**Service Letter #:** SL07-35A-45050 Shear Pin

**Date:** 09/02/14

**Part/Assembly #:** 35A-45050 Shear Pin

**Float Model/Aircraft Affected:** Aerocet Model 3400 Amphibious Floats, Serial #330 and later, and any earlier floats in which cotter style shear pins have been replaced with the retaining ring style. (35A-45050, I/R is cotter pin style, while 35A-45050, Rev A is retaining ring style.)

**Figure 1 - Showing Main Landing Gear and 35A-45050 Pin Installation**

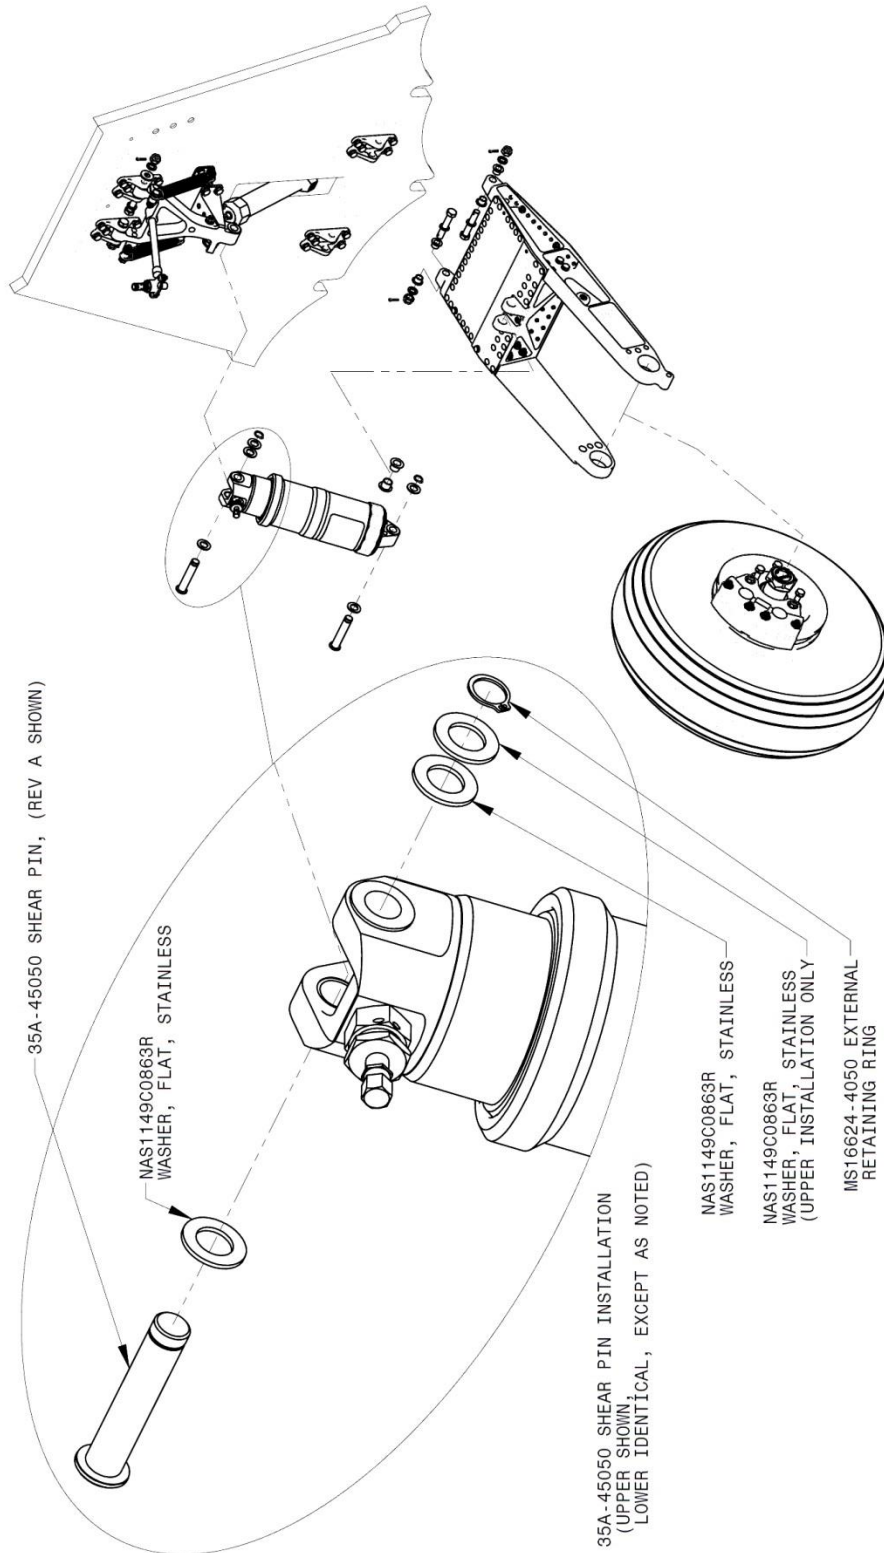
**Symptom:** MS16624-4050 Retaining Ring yielded due to over-spreading on installation.

It has been discovered that mechanics have overstretched the retaining rings that hold these pins in place upon either installation or removal of the shock strut reducing their retaining ability. As a result, retaining of the shock strut connecting pins may be lost.

Assure that the connecting pins for the main gear shock strut (oleo) are secured (both top and bottom) with their respective retaining rings (Circlips, snap rings). (See Illustration on following sheet)

A further examination should be done by reaching in and rotating the retaining ring(s). If the retaining ring(s) rotates easily (no drag) then it likely has been overstretched and should be replaced.

**Any reinstallation of these connecting pins should be done with new retaining rings.**

These retaining rings are a common aviation product – part number MS16624-4050. They are available from us at cost plus shipping.
